**City of Seattle**  
Seattle Public Utilities

**SUBJECT:** Henderson Basin 44 and 45 CSO Reduction Project  
Addendum to Final EIS, Revised Final EIS, and Determination of Non-Significance

**Henderson Basin 44 and 45  
CSO Reduction Project**

Addendum to Final EIS, Revised Final EIS, and Determination of Non-Significance

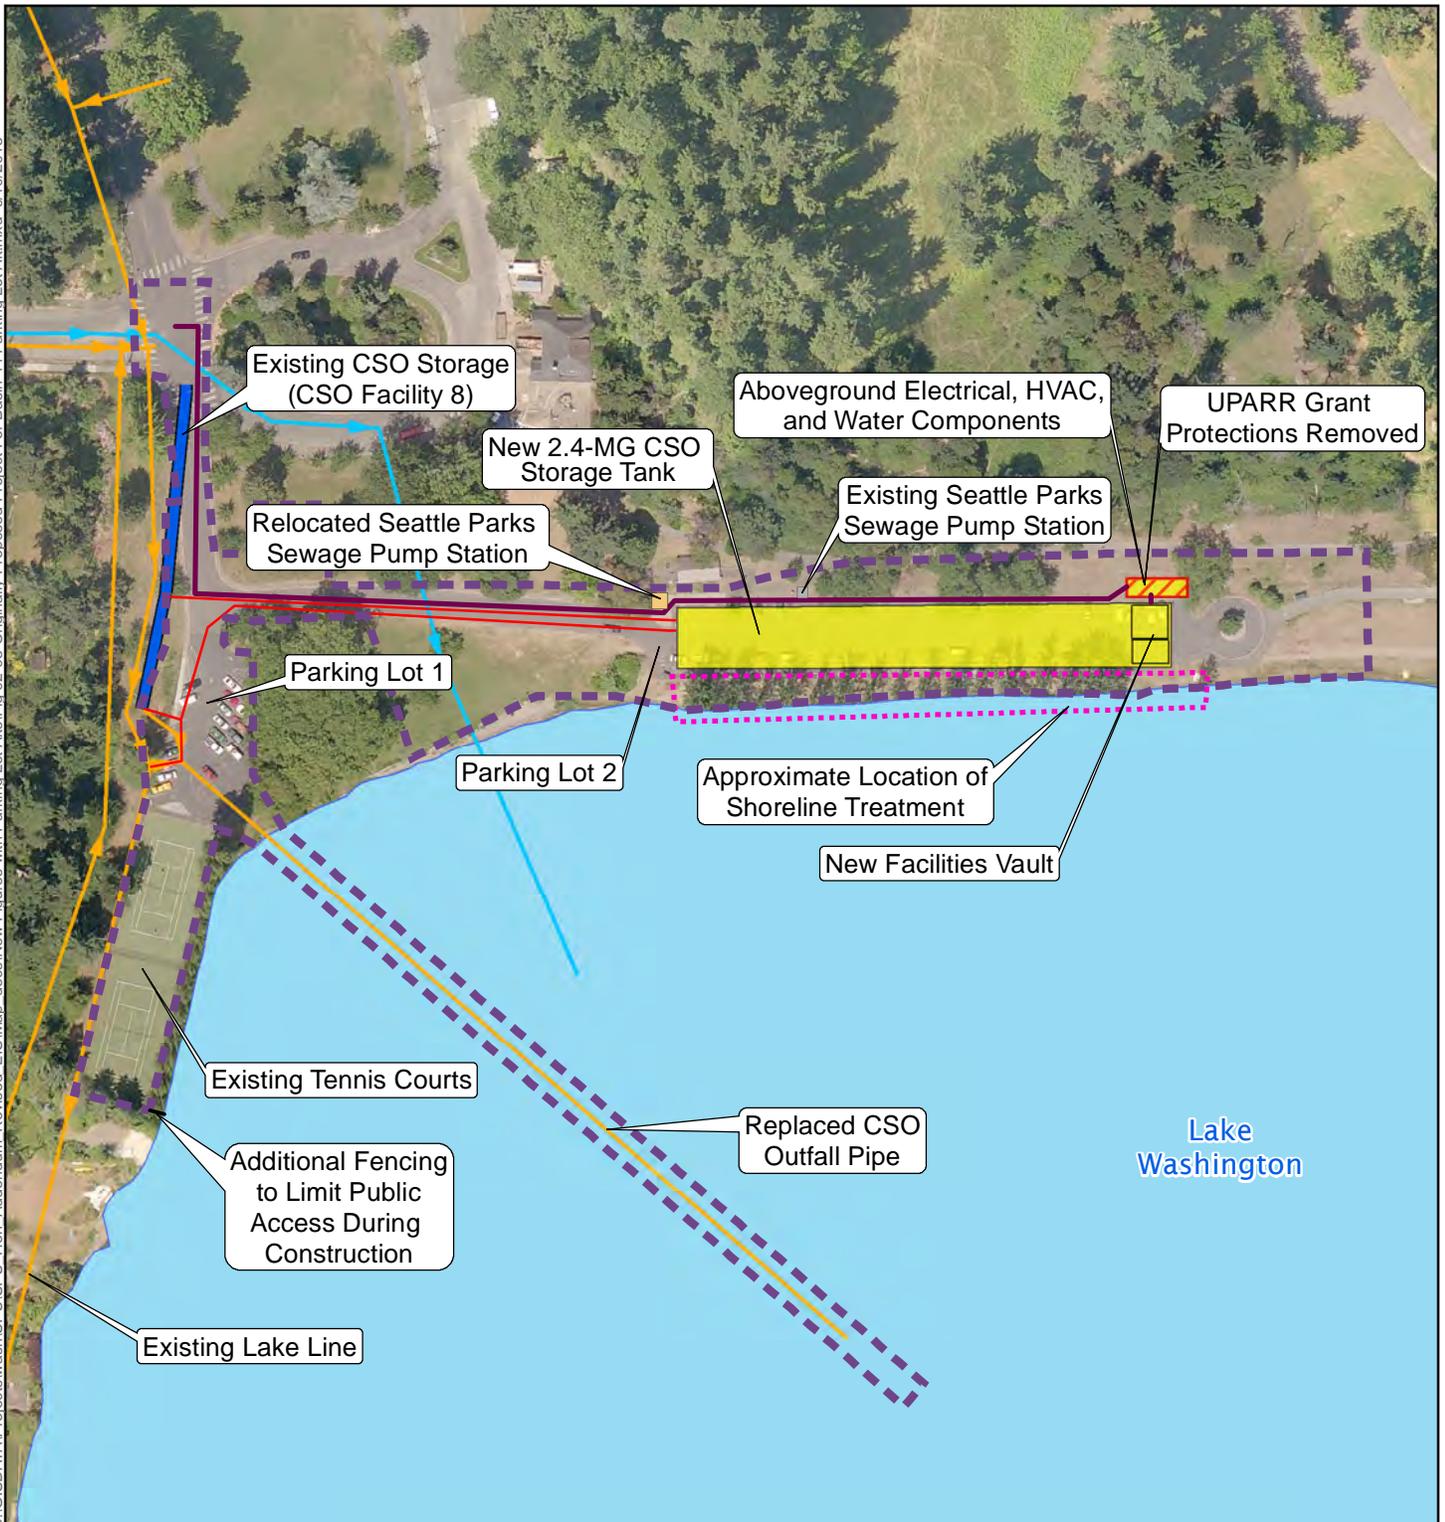
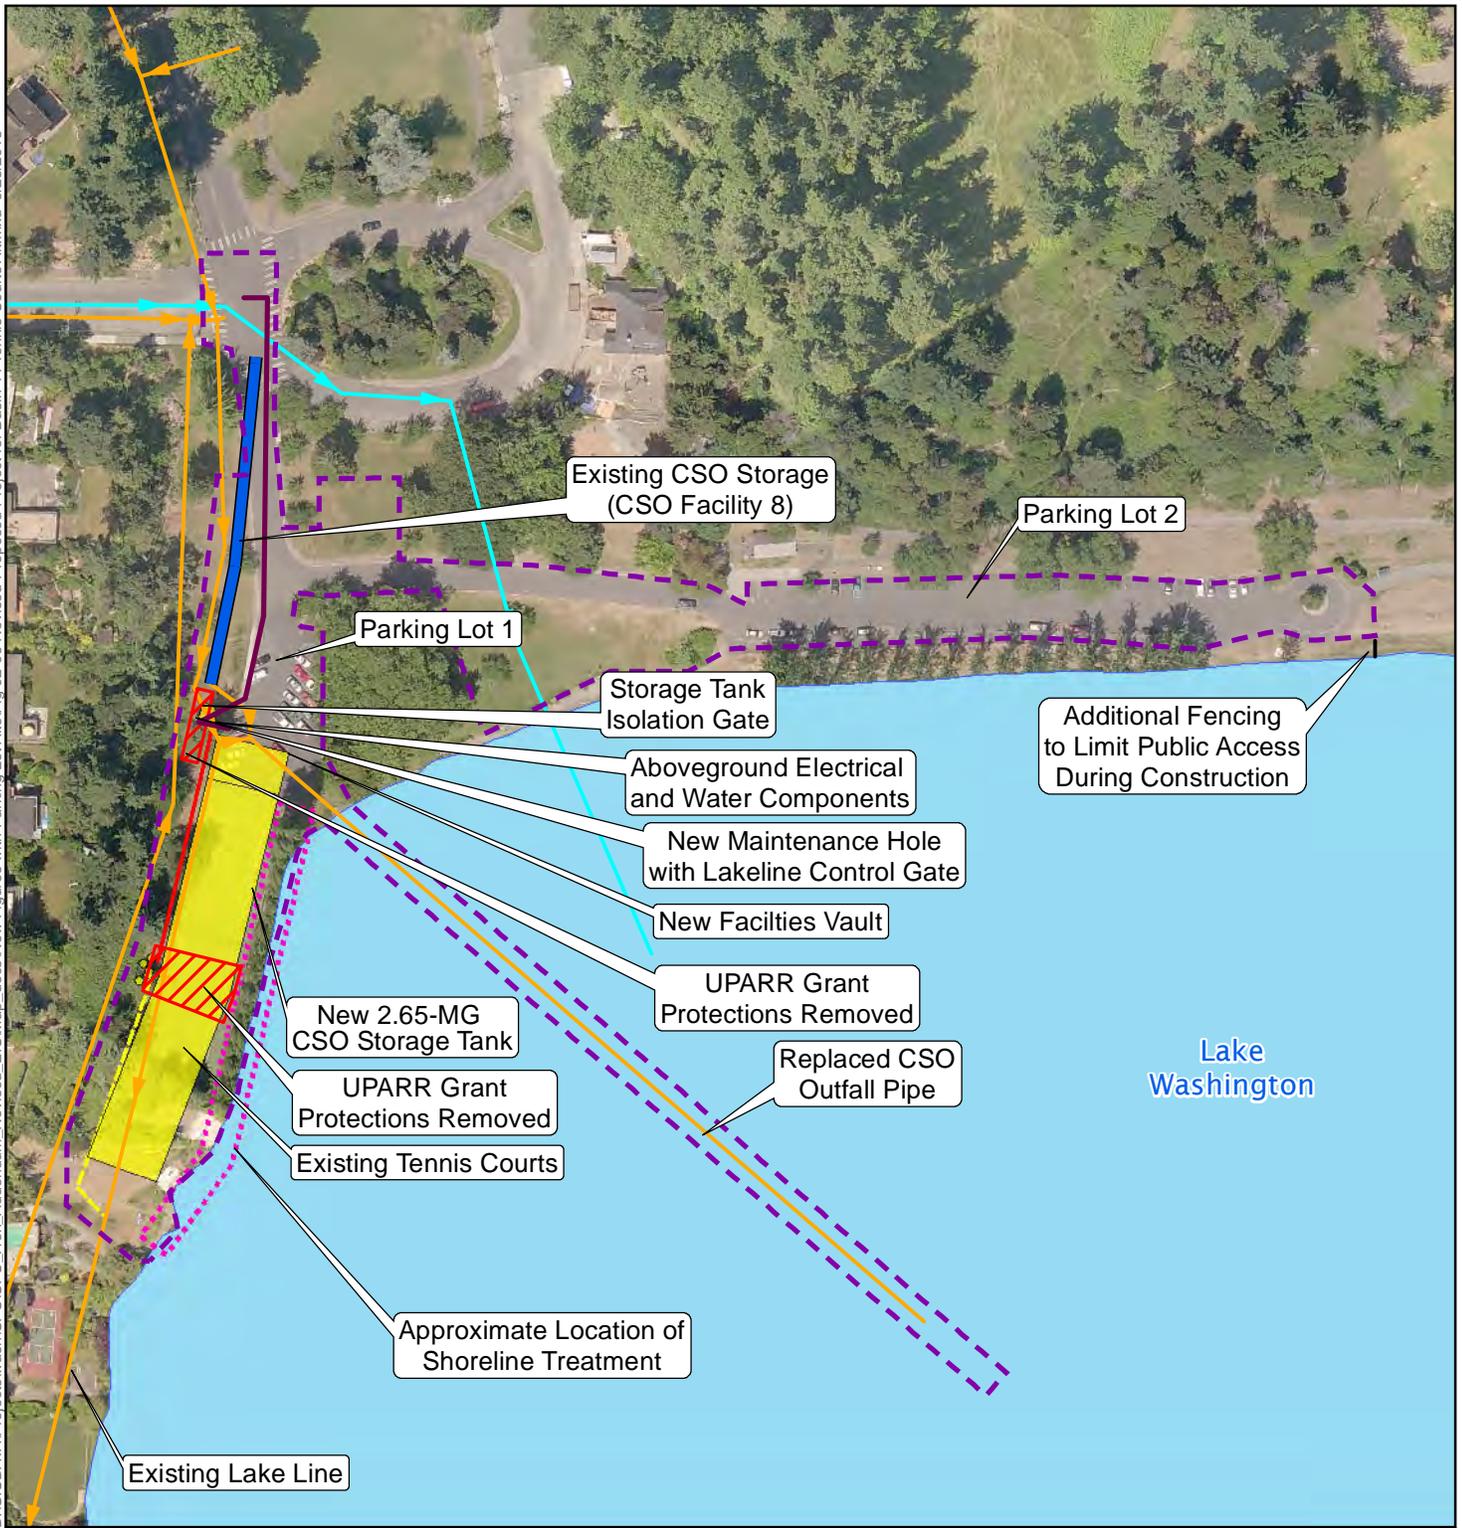
The proposed combined project would require changing three elements of the originally proposed Henderson Basin 44 CSO Reduction Project, as described below. Figure 2-6 (Tennis Courts Alternative) and Figure 2-7 (Parking Lot Alternative) show the major project elements and features of the Basin 44 components with the proposed design changes described in this section. These proposed design changes would not change the permits required for the project, as listed in the 2013 Revised Final EIS (SPU 2013b) and Section 3.4 of this Addendum. In addition, there is the potential to add a temporary energy dissipation structure for dewatering discharge that was not part of the originally proposed project.

The primary design change proposed in Basin 44 is an increase in the storage capacity of the underground tank from 2.4 million gallons to 2.65 million gallons. For both the Parking Lot and Tennis Courts Alternatives, this volume would be obtained by increasing the width and decreasing the length of the originally proposed tank and optimizing the structural design of the tank within the constrained site (see Table 2-1). Though the volume of the tank would increase, the tank would be accommodated within a similar footprint compared to the originally proposed tank (approximately 18,900 square feet for the revised proposed project versus approximately 18,800 to 19,500 square feet<sup>2</sup> for the originally proposed project) because of the following:

ORIGINALLY PROPOSED PROJECT FOR BASIN 45

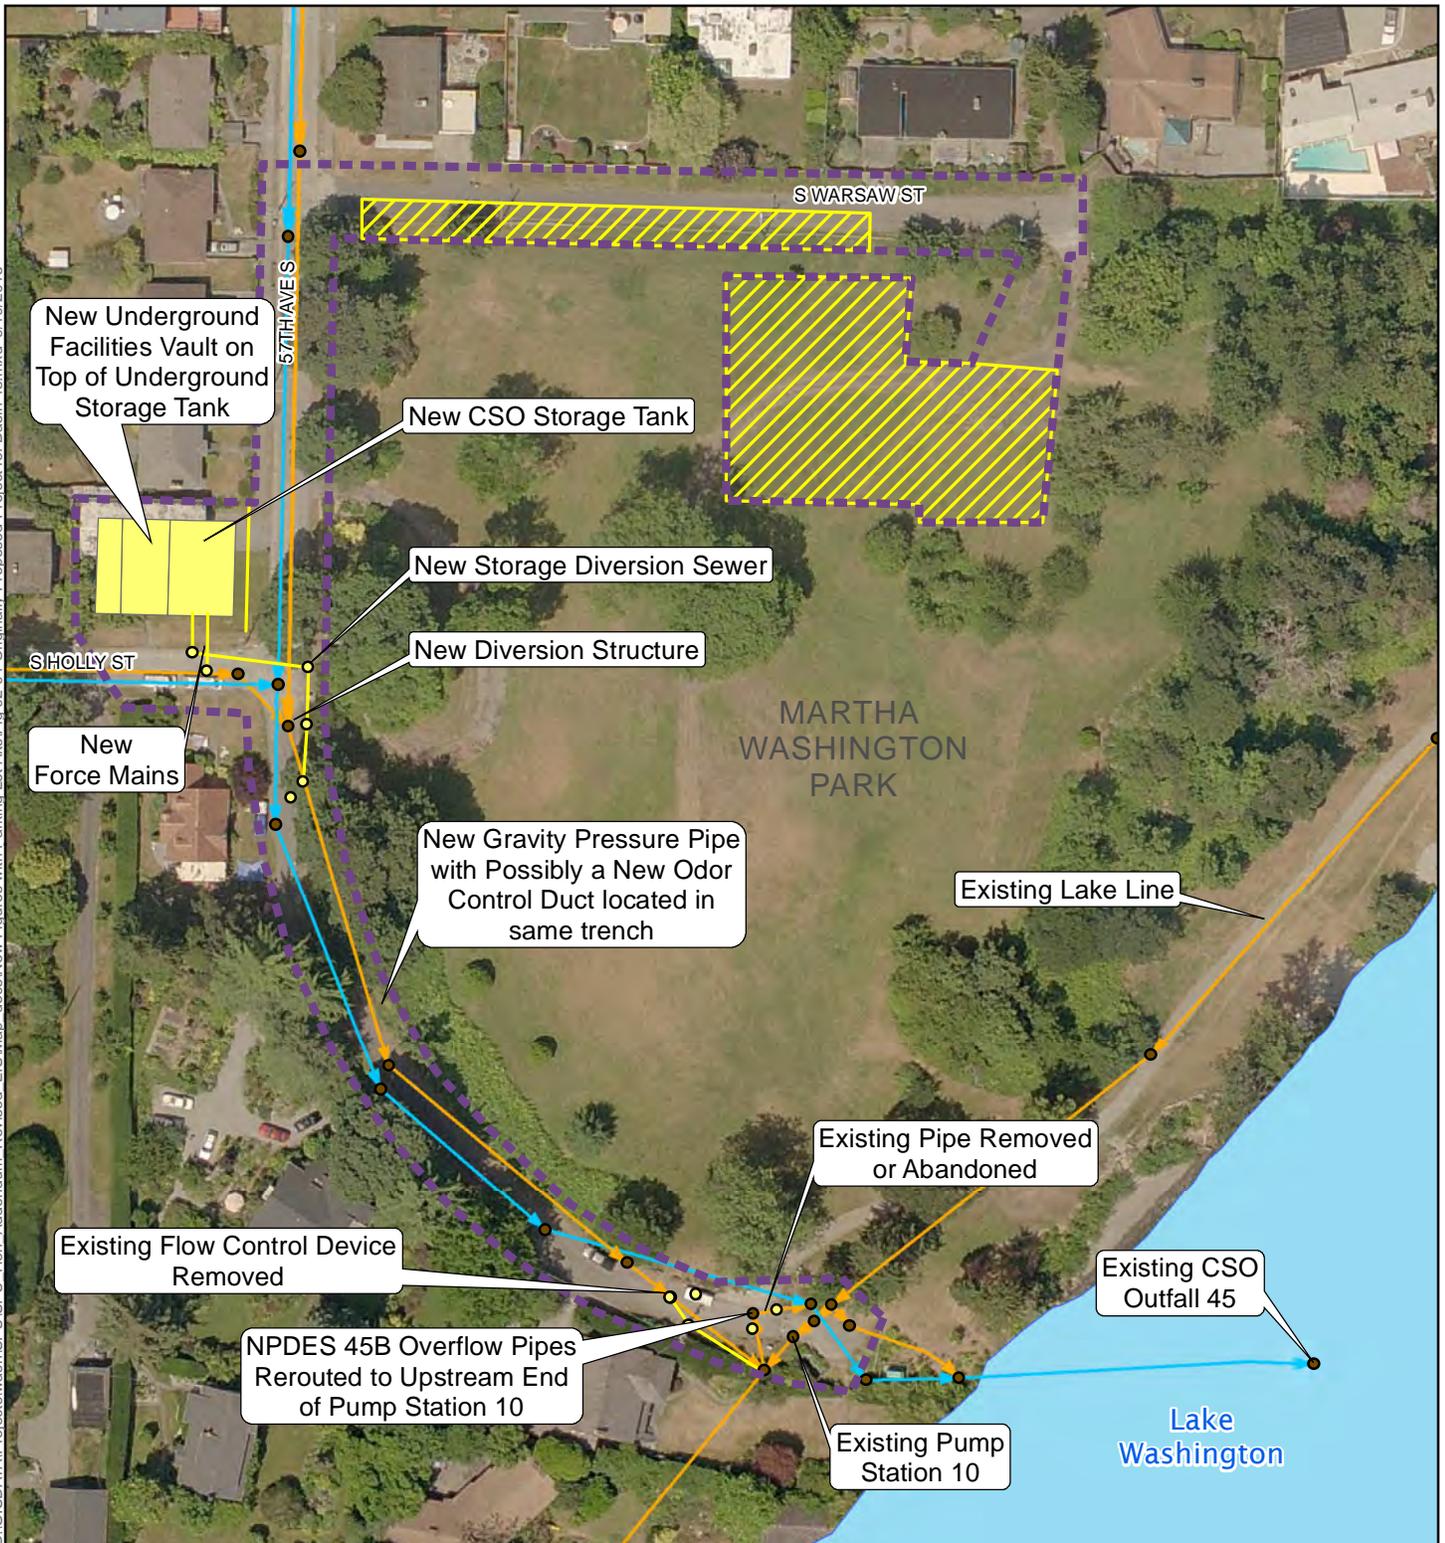
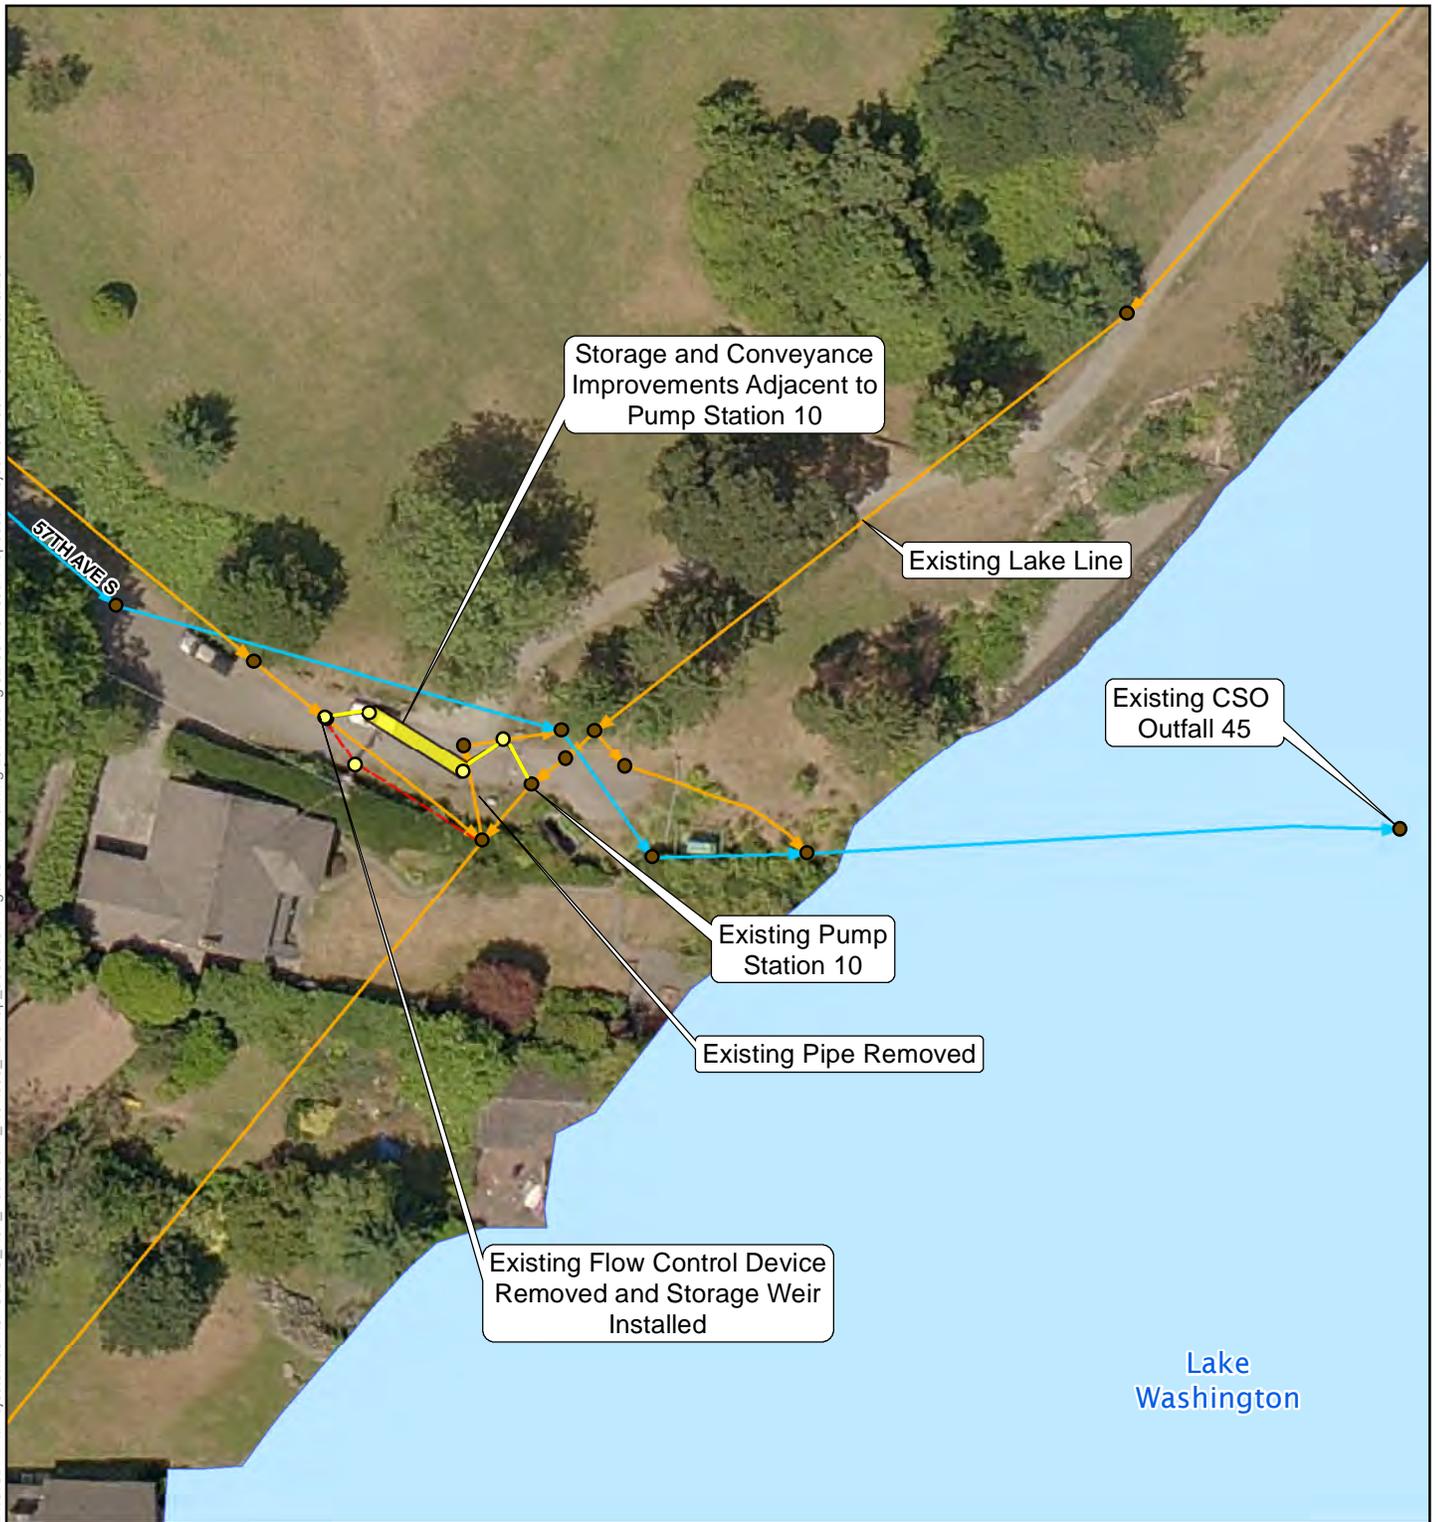
The primary change in design in Basin 45 would be the elimination of the underground storage tank, originally proposed to be placed under private property. The reduced Basin 45 storage volume of 16,000 gallons can be accommodated within a new underground storage pipe and associated maintenance holes. The storage volume in Basin 45 can be significantly reduced because the storage tank in Basin 44 was increased in size and the two basins would operate as a single system. This storage pipe would be an approximately 96-inch-diameter, precast, reinforced concrete pipe and would be approximately 40 feet long. The two maintenance holes, one at either end of the pipe, would be approximately 8 feet in diameter. The storage pipe and maintenance holes would be buried under the 57th Avenue South right-of-way near the CSO outfall and existing buried pump station (Pump Station 10). Its location would eliminate the need for the previously acquired private property and eliminate the conveyance improvements needed by the originally proposed storage tank.

The storage pipe would fill by gravity and drain by a float-actuated valve. Odor control, pumping, and flushing systems would no longer be required (see Table 2-1). SPU would operate and maintain the storage pipe similar to the numerous existing offline storage pipes that are installed throughout its combined sewer system. Eliminating the underground storage tank also would reduce the area of temporary disturbance by 0.6 acre (from 0.7 acre to approximately 0.1 acre), and would reduce construction duration from up to 18 months to approximately 4 to 6 months. See Figure 2-8 for the major Basin 45 elements of the revised proposed project.

**Odor Control Air Duct Gooseneck**

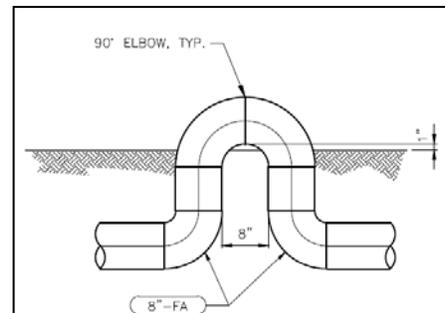
- **Odor Control Air Duct Gooseneck:** An 8-inch-diameter odor control air duct gooseneck has been added to the aboveground components area. The gooseneck would come aboveground and then head back underground with no openings to the atmosphere as indicated in the image to the right. The gooseneck has been added to protect the carbon vessel by preventing combined sewage from back-flowing into the carbon vessel.
